Final Drainage Report
for
“Town of Monument Water Tank Site”

744 Forest View Way
Town of Monument, Colorado, 80132

PCD File Number - PPR-21-030

January 10, 2022

PROPOSED DRAINAGE PLAN

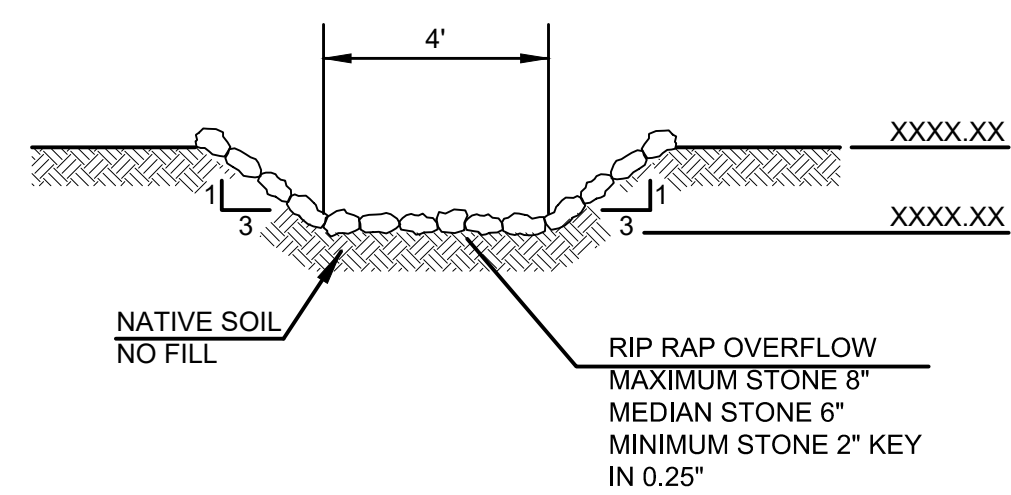
Please shade areas excluded from WQ treatment on this map or a new map, per comments on PBMP Form.
